NRC DOCKETS 50-321, 50-366
OPERATING LICENSES DPR-57, NPF-5
EDWIN I. HATCH NUCLEAR PLANT UNITS 1, 2
NRC I&E BULLETIN 80-11

NRC I&E BULLETIN 80-11, "MASONRY WALL DESIGN"

RESPONSE TO NRC REQUEST FOR
ADDITIONAL INFORMATION

EDWIN I. HATCH NUCLEAR PLANT

Project	HATCH-UNIT NO.1 & 2	Prepared By	TINA C. SALSER	Date	11-19-87
Subject/Title	WALL MODIFICATION	Reviewed By	K. L. WHITMORE	Date	11-21-80
C-130-2A & 2B (PSOC-30-002)		Calculation Number		Sheet	4 of 7

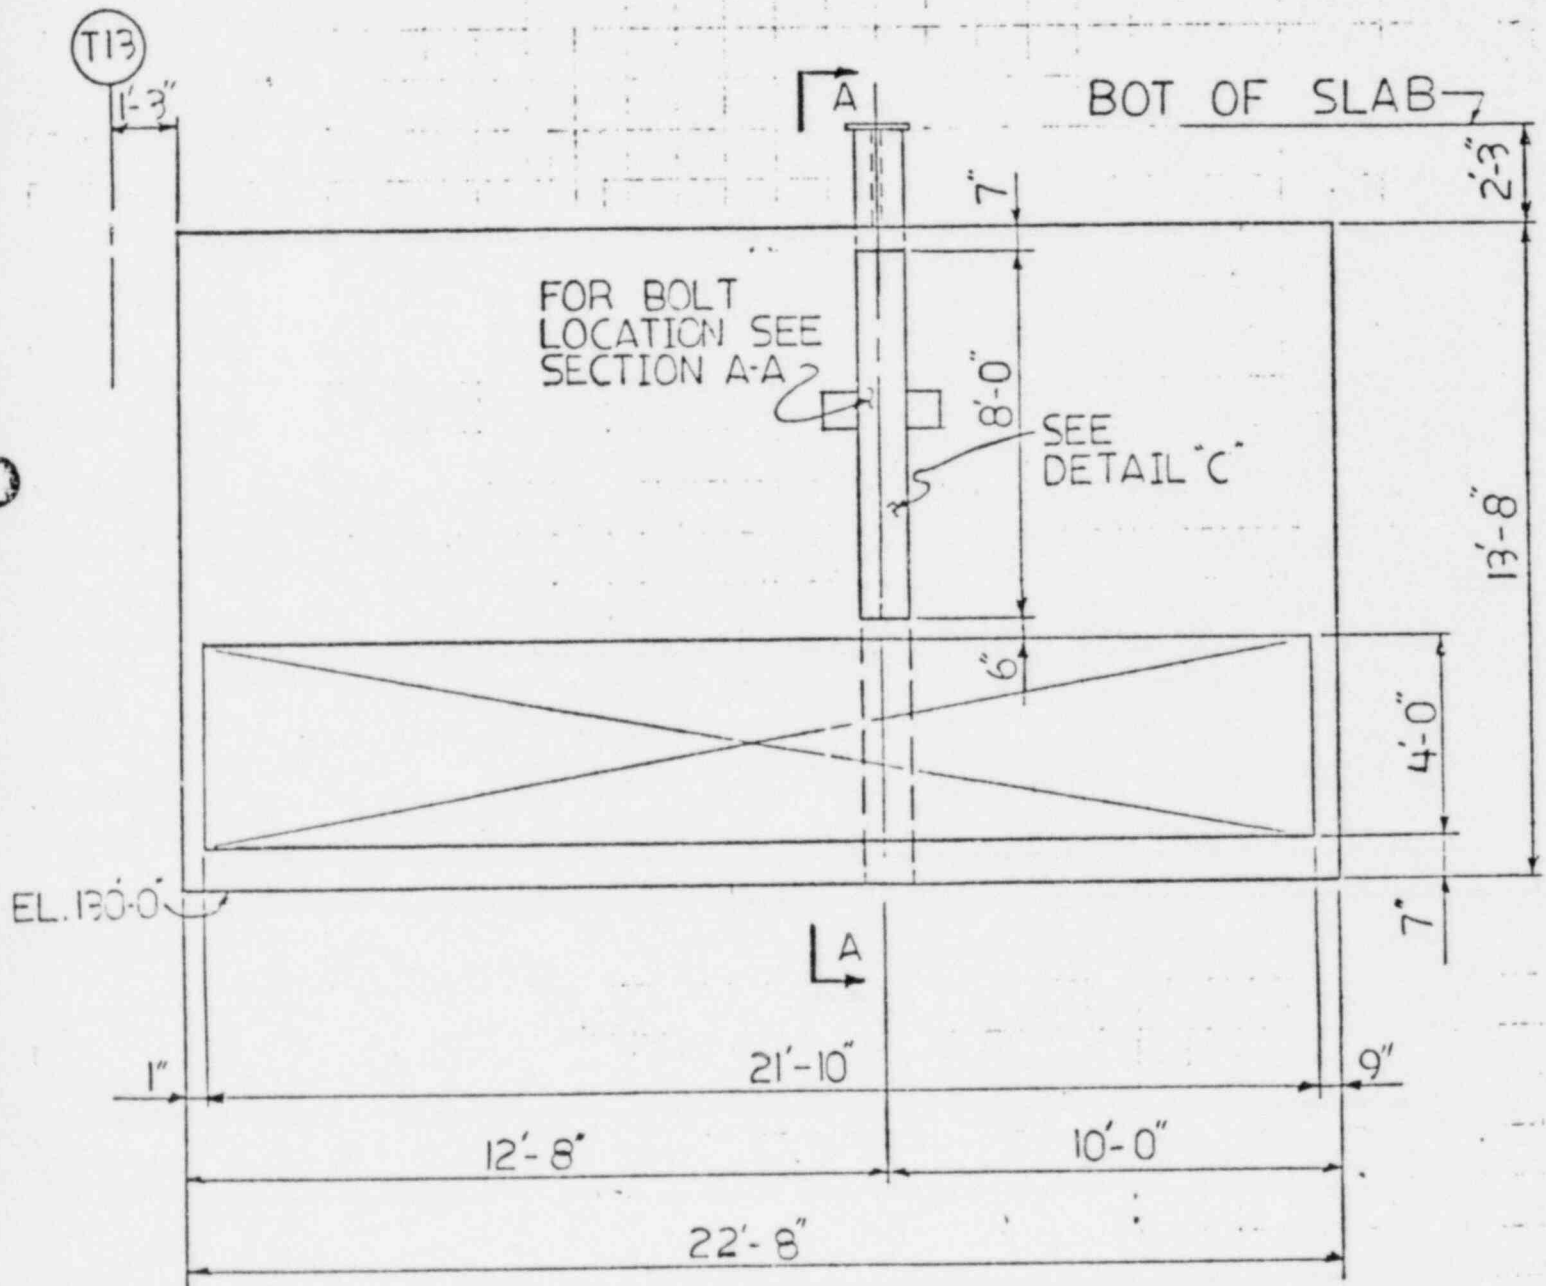
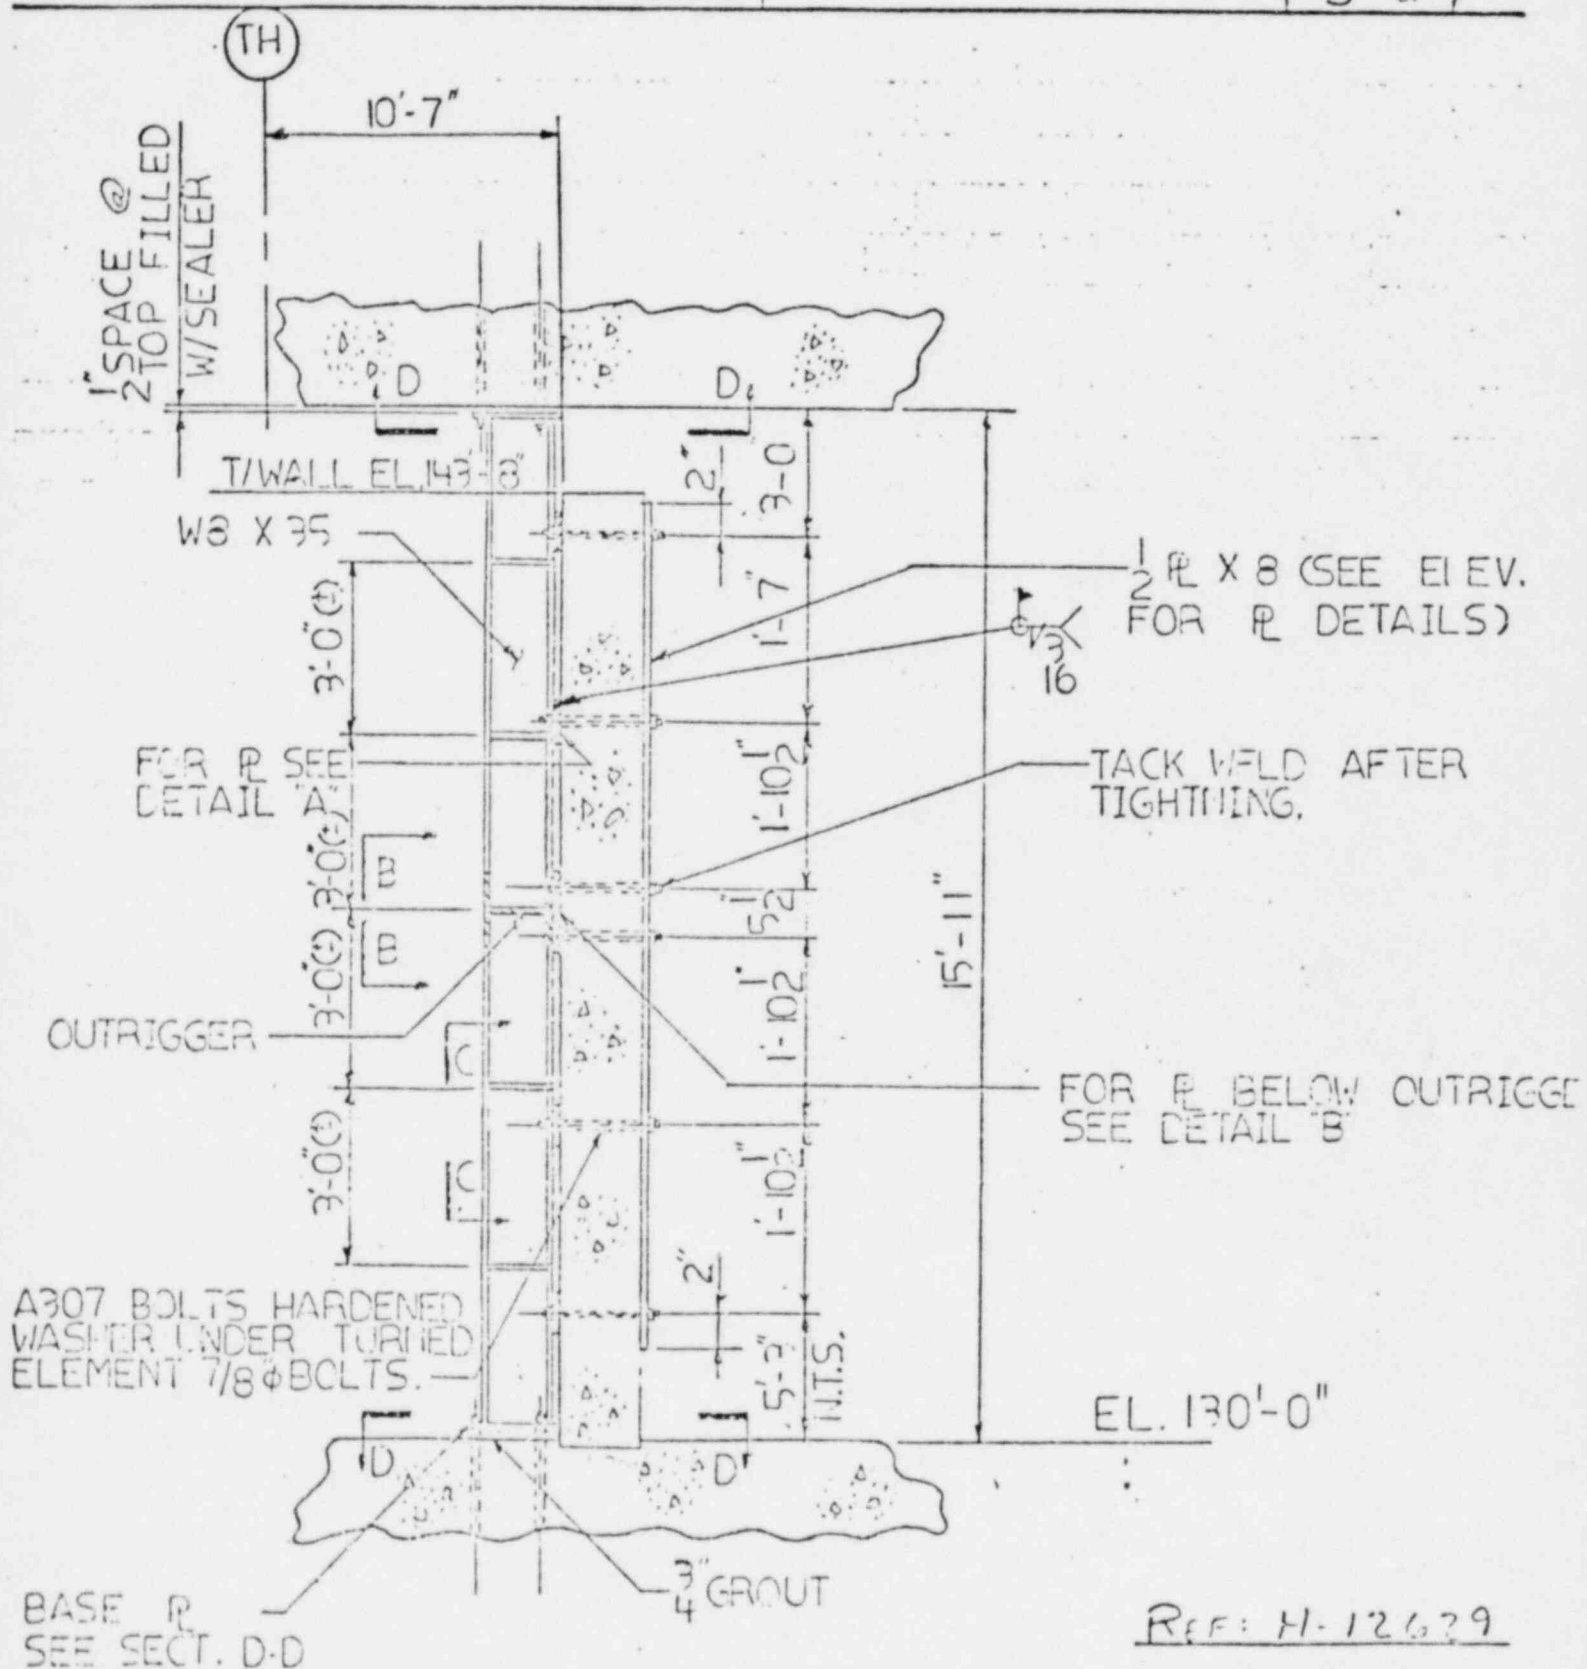
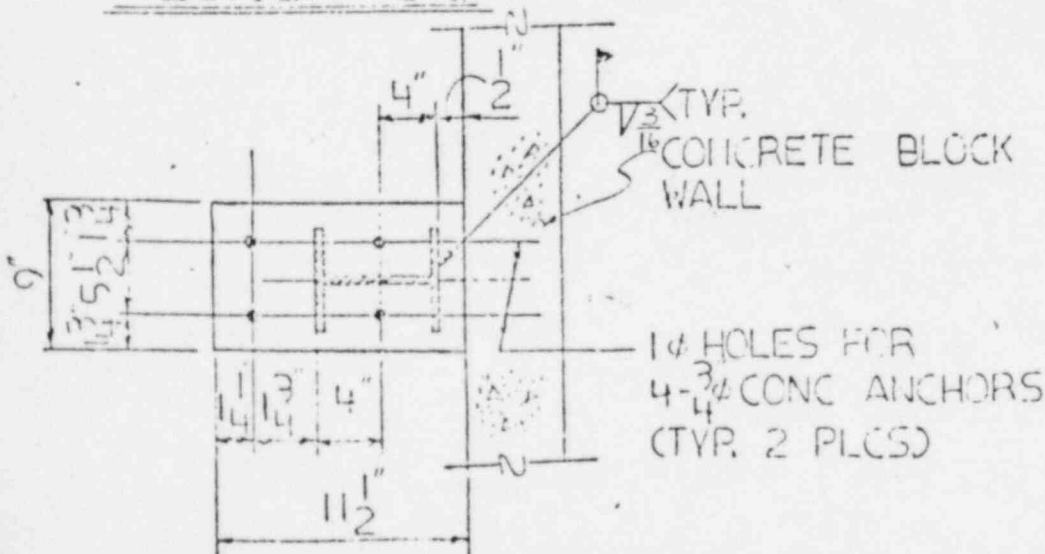
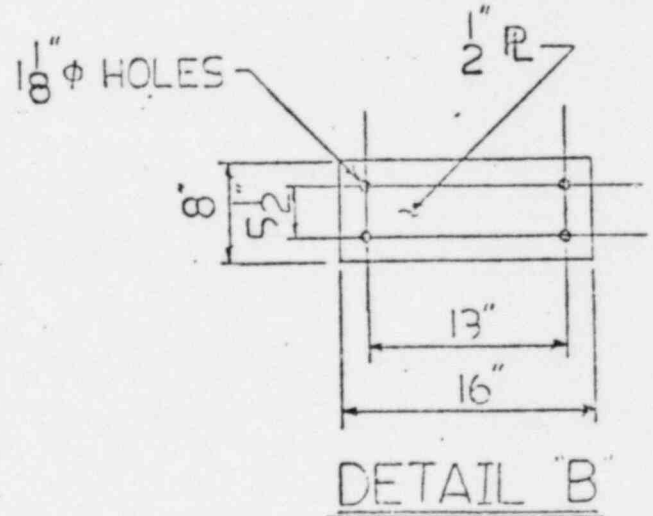
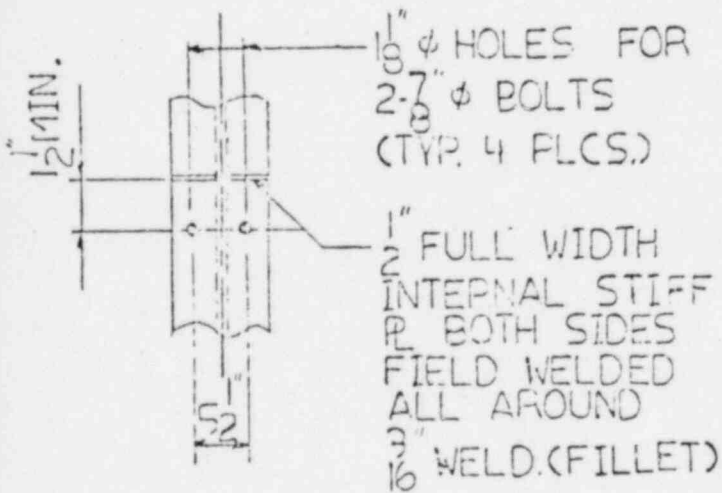
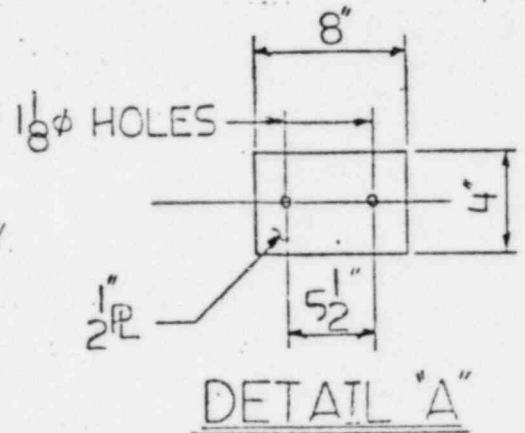
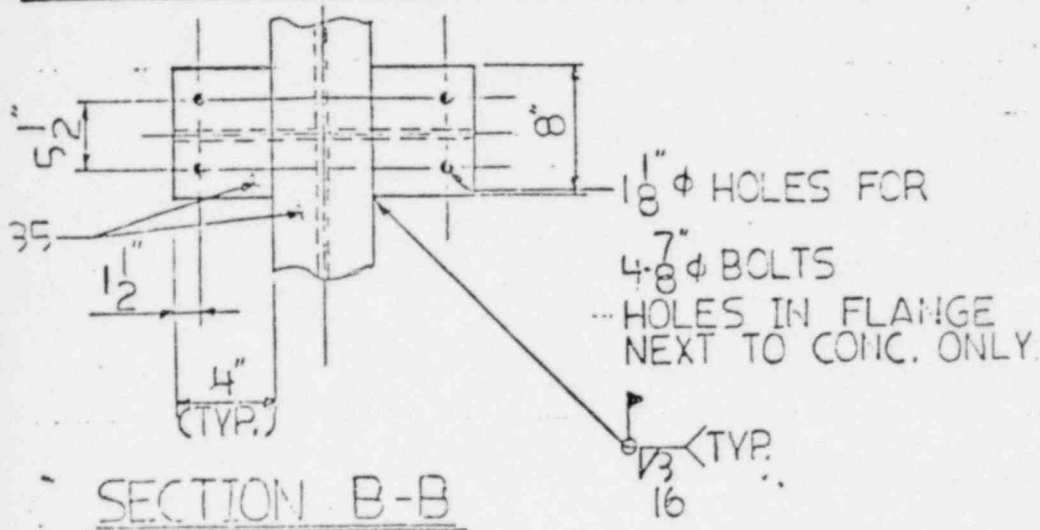
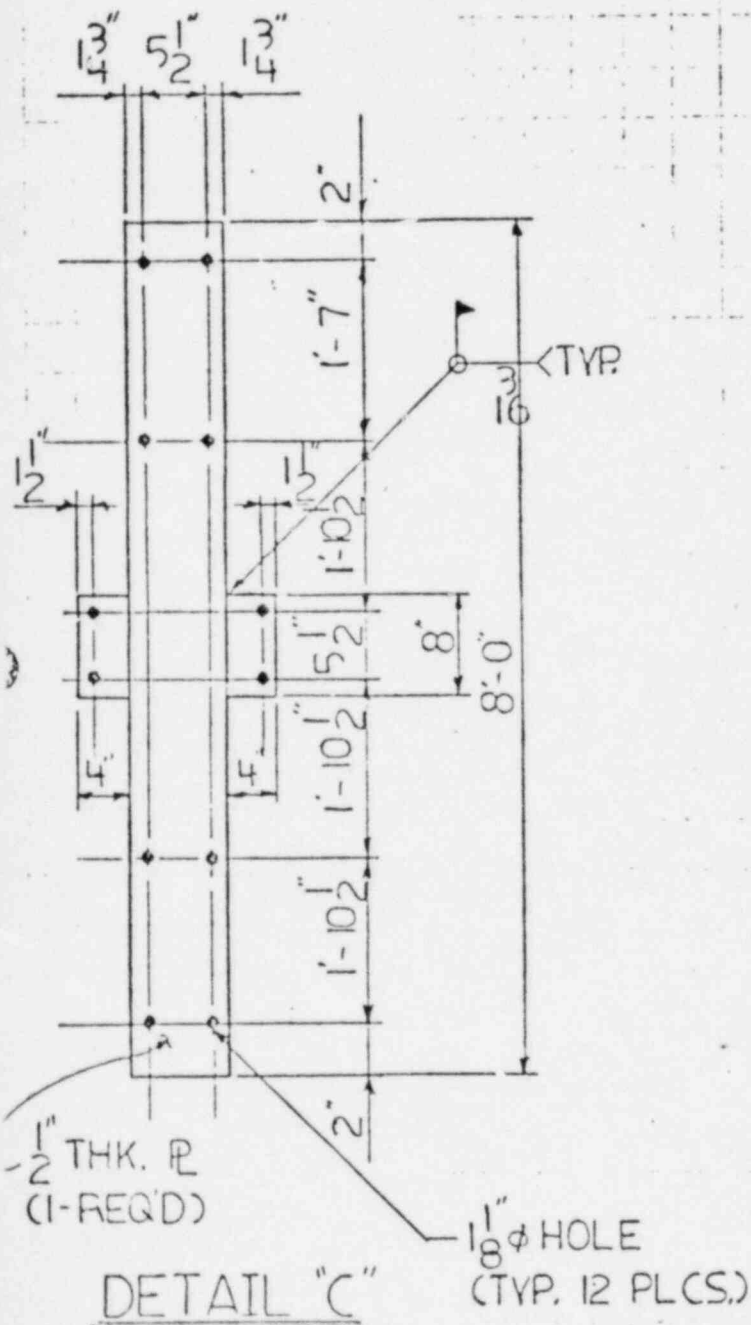
Provide details of modifications for all walls that do not satisfy the design allowables. Technical discussion should be provided detailing how these modifications will correct this deficiency. Also, provide the modification schedule.

A number of walls were modeled for STRUDL-DYNAL and had a finite element analysis run of the as-built condition, taking into account all loads and load combinations. A total of ten (10) walls were identified where calculated stresses exceeded allowable stresses. The results of the analysis showed that the effective horizontal span length of the wall should be reduced. Therefore, a point somewhere within the middle one-third of the span of the wall was chosen considering obstructions and installation problems, and one or more structural steel columns were erected to provide additional support for the wall. The column(s) were designed to withstand the applied loads and were used to brace the wall as shown in the attached sketches. The wall was then re-modeled for STRUDL-DYNAL, including the steel column, and a finite element analysis was performed again for all postulated loads and load combinations. Resulting moments and shears for the masonry wall and support column were checked against allowables. In addition, bolts, plates, and welds for the support having an angle brace were checked for worst-case loads. Wall number C130-14A&B had an angle brace attached to the ceiling on each side of the wall to provide lateral shear support and reduce a local overstress condition to within allowables. Following the analysis using the modified models, each wall was determined to satisfy all stress allowables.

Detailed sketches of the modification for each wall are shown in attachments 1 through 8. The field modifications for each wall are complete except for wall C164-4A&B and wall C130-39A&B. Both of these walls will be removed in the near future to allow for relocation of the shift supervisors office and modifications in the health physics area. Therefore, no modifications have been scheduled for these walls.
